TOWN OF NEWBURGH
PLANNING BOARD
TECHNICAL REVIEW COMMENTS

PROJECT: SERVISS 4 LOTSUBDIVISION

PROJECT NO.: 19-10

REVIEW DATE: 29 AUGUST 2019 MEETING DATE: 5 SEPTEMBER 2019

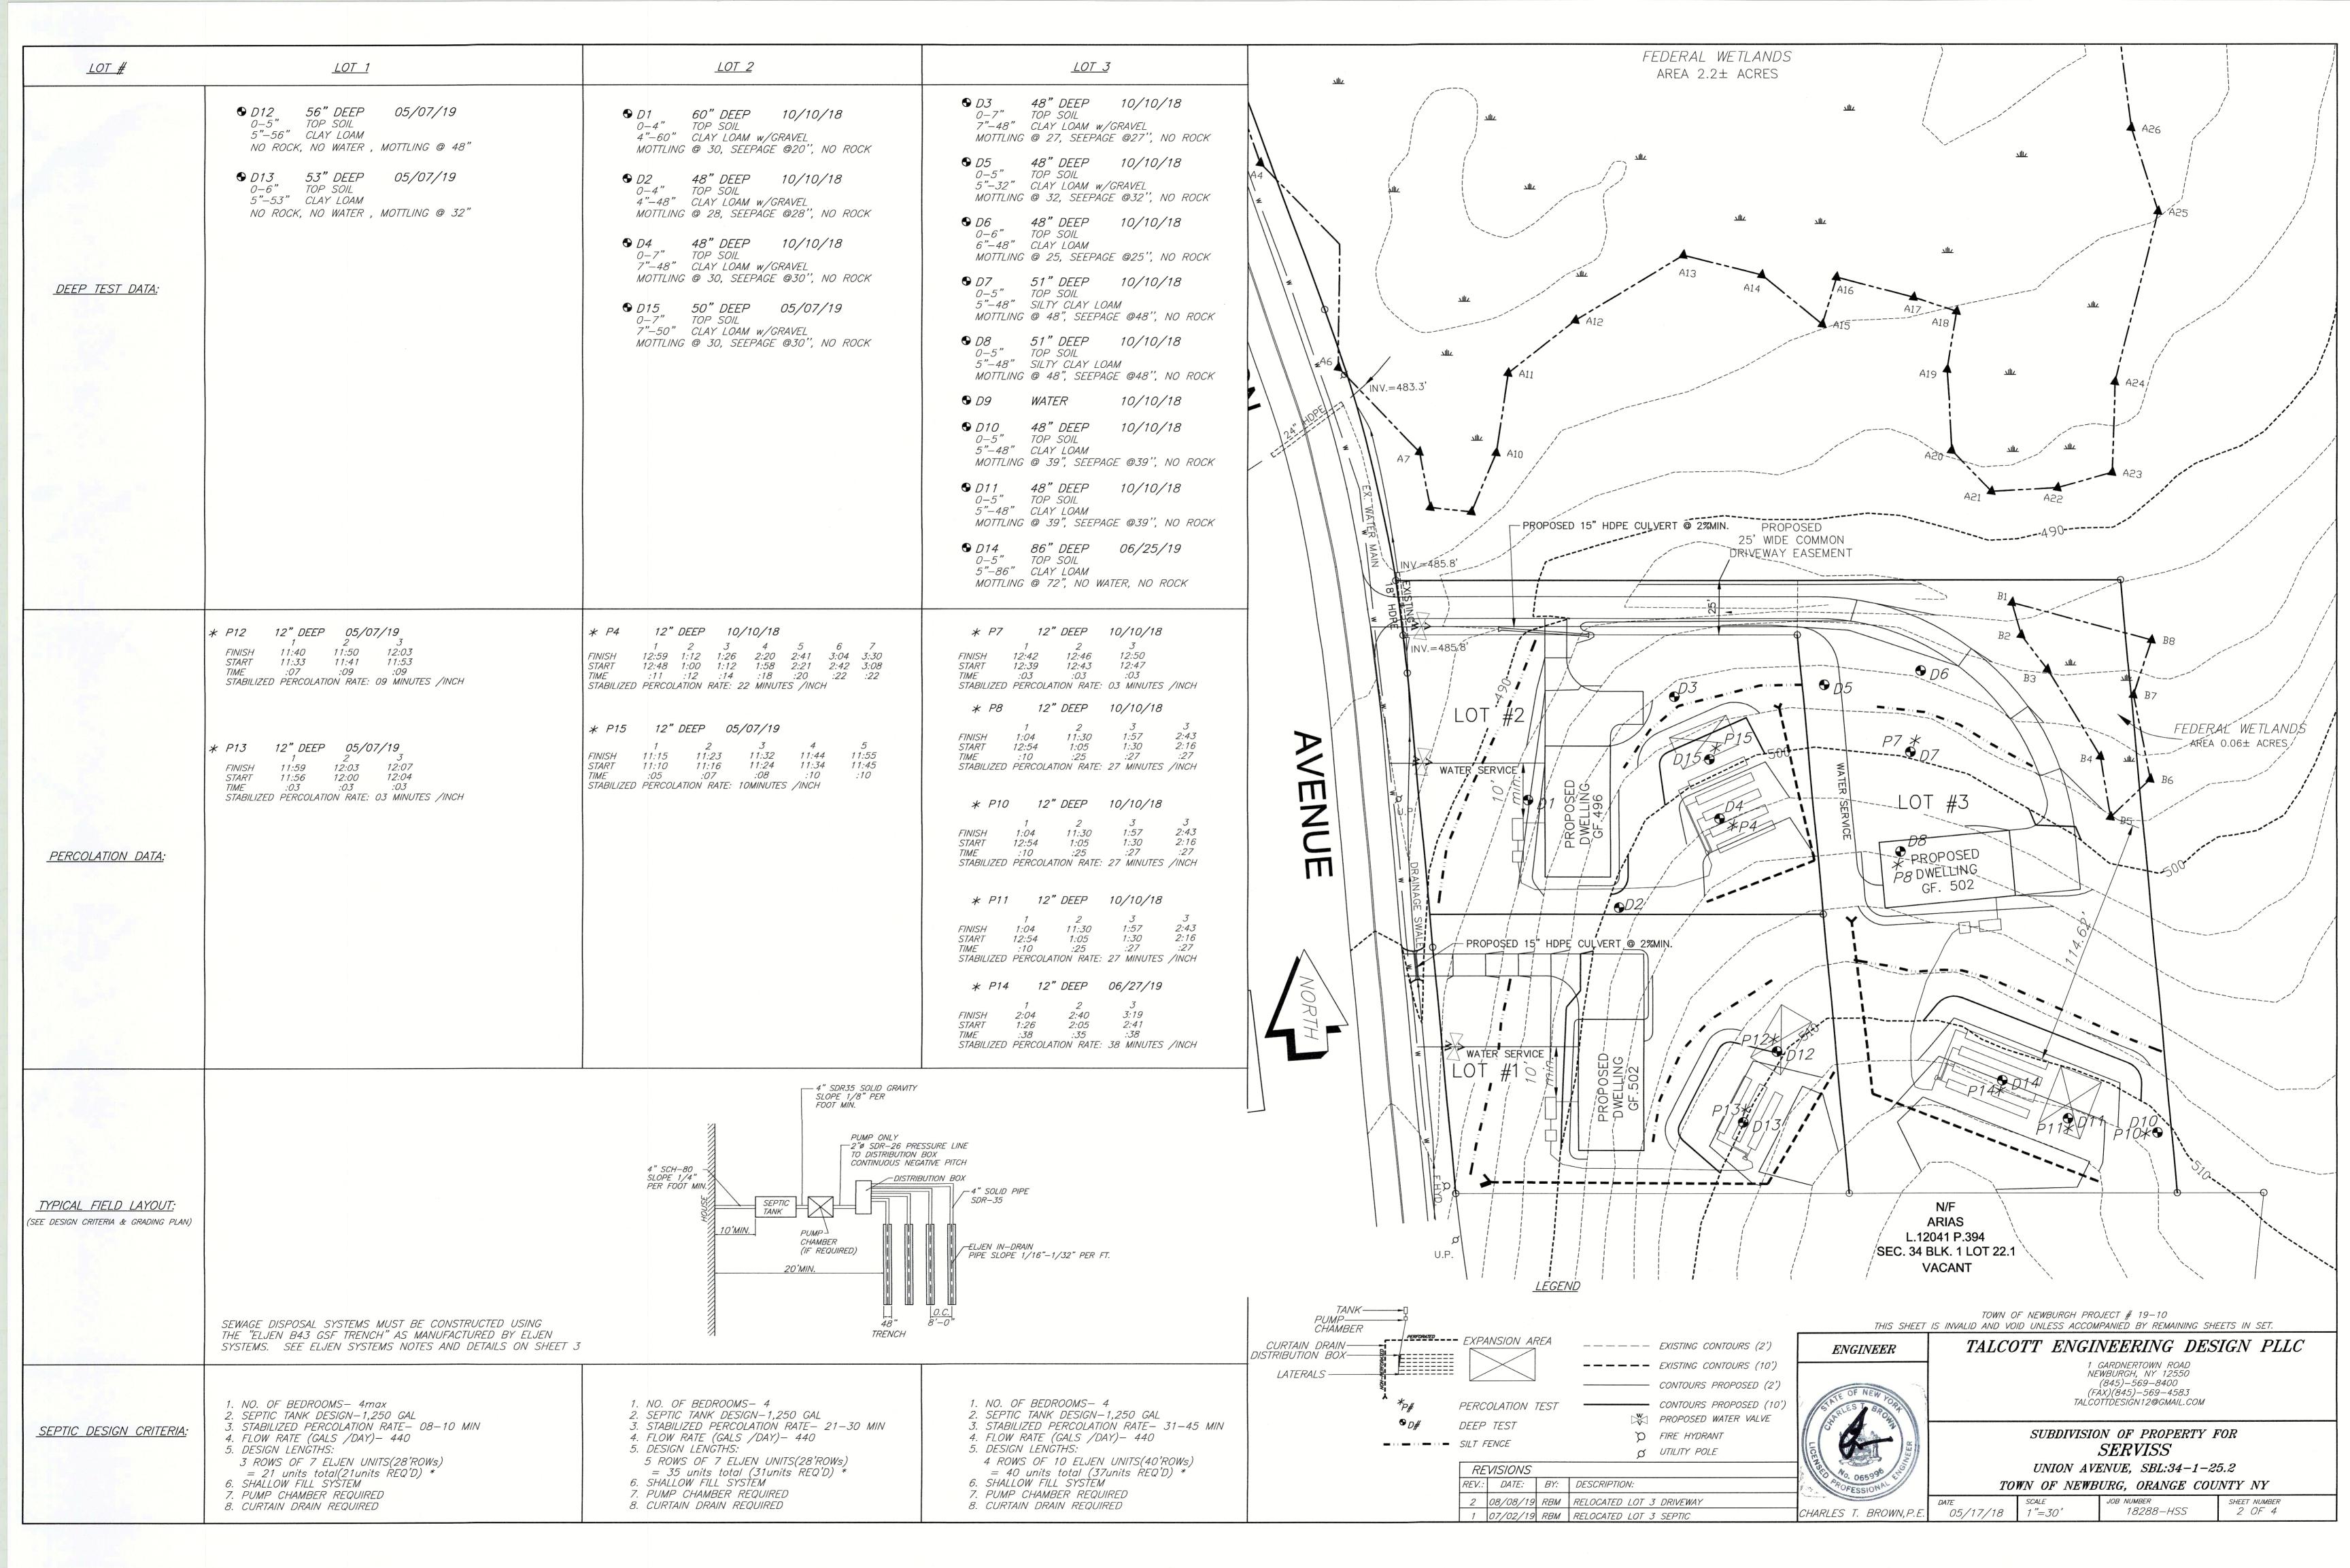
- 1. Highway superintendent's comments regarding the location of the access drives should be received.
- 2. Lot 3 has been revised to modify the building location and subsurface sanitary sewer disposal system to eliminate the previous federal wetland filling depicted on the lot. Separation distance between the wetland and the subsurface sanitary sewer disposal system has been provided.
